**ZONING AMENDMENT,
PLANNED UNIT DEVELOPMENT &
SUBDIVISION STAFF REPORT**

Date: September 15, 2011

<u>NAME</u>	La Belle LLC.
<u>SUBDIVISION NAME</u>	La Belle Subdivision, Re-subdivision and Addition to Lot 1
<u>LOCATION</u>	5951 & 5955 Old Shell Road and 14 East Drive (Southwest corner of Old Shell Road and East Drive)
<u>CITY COUNCIL DISTRICT</u>	District 6
<u>PRESENT ZONING</u>	R-1, Single-Family Residential District, and B-2, Neighborhood Business District
<u>PROPOSED ZONING</u>	B-2, Neighborhood Business District
<u>REASON FOR REZONING</u>	Subdivision of land, and resolution of a split-zoning issue created by the proposed Subdivision.
<u>AREA OF PROPERTY</u>	1 Lots / 1.3 ± Acres
<u>CONTEMPLATED USE</u>	<p>Subdivision approval to create 1 lot, Planned Unit Development Approval to amend a previously approved Planned Unit Development to allow multiple buildings on a single building site, and Rezoning from R-1, Single-Family Residential District, and B-2, Neighborhood Business District, to B-2, Neighborhood Business District to eliminate split zoning in a proposed Subdivision and allow construction of a parking lot.</p> <p>It should be noted, however, that any use permitted in th

SITE PLAN

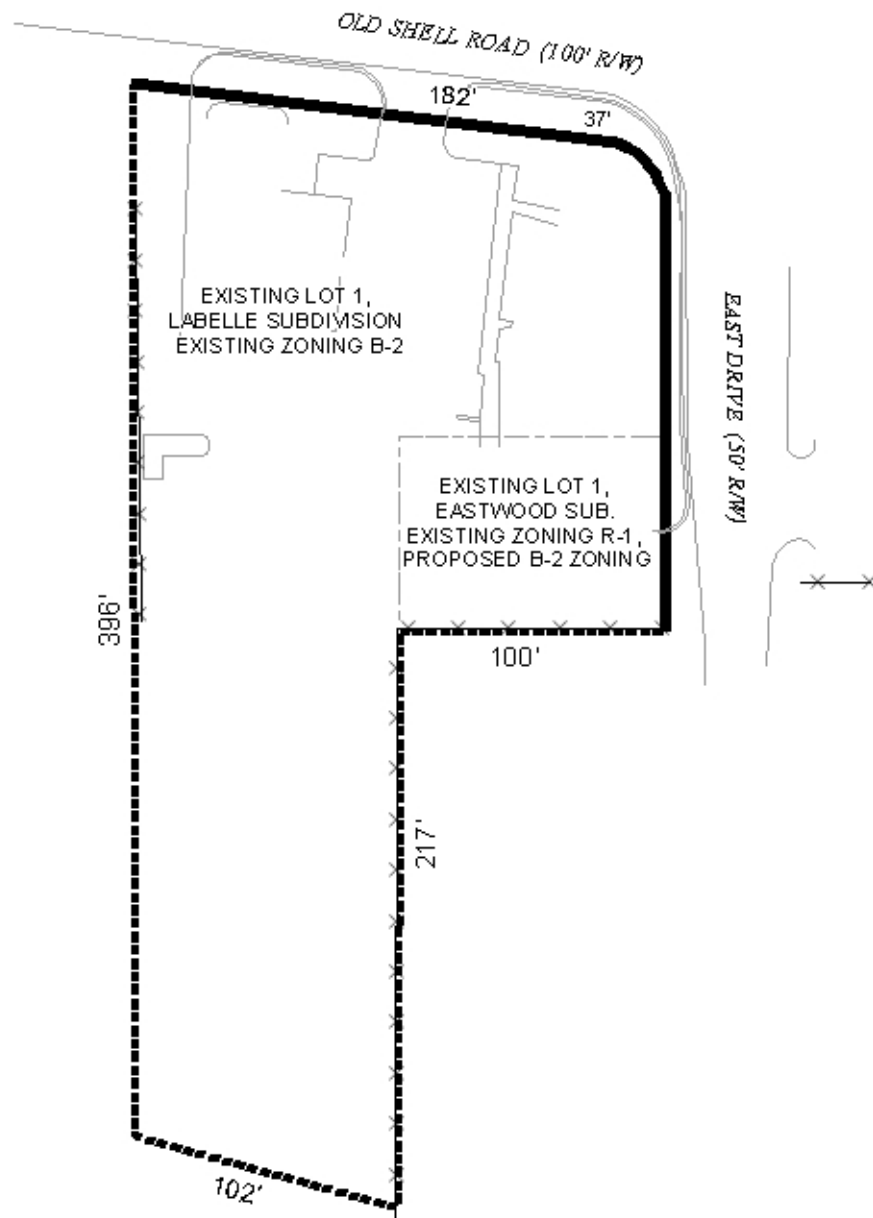
<u>TIME SCHEDULE</u>	No timeframe provided.
<u>ENGINEERING COMMENTS</u>	Must comply with all storm water and flood control ordinances. Detention required for the approximately 1,300 square feet of impervious area added to the site since 1984 in addition to the proposed parking lot as shown on the submitted

site plan. Any work performed in the right of way will require a right of way permit. Drainage from any dumpster pads cannot discharge to storm sewer; must have connection to sanitary sewer.

Driveway number, size, location, and design to be approved by Traffic Engineering and conform to AASHTO standards. The proposed concrete driveway on East Drive is skewed at an approximate 60° angle. Exiting traffic is aimed away from Old Shell Road; vehicles not likely to exit at this angle will block southbound vehicles from entering the driveway. Driveway should be designed with minimum skew; 90° angle is desired. A 20' radius is typical for passenger cars and a 30' radius is desirable for large trucks. The distance between the edge of pavement and right-of-way line (approximately 10') and the proximity of live oak trees may prohibit the proper radius; if so largest possible radii are desired.

vehicles entering the site from southbound East Drive. A large live oak tree in the proximity of the proposed curb-cut may be the reason for the proposed design, however, Traffic Engineering has requested as close to a 90-degree driveway as possible.
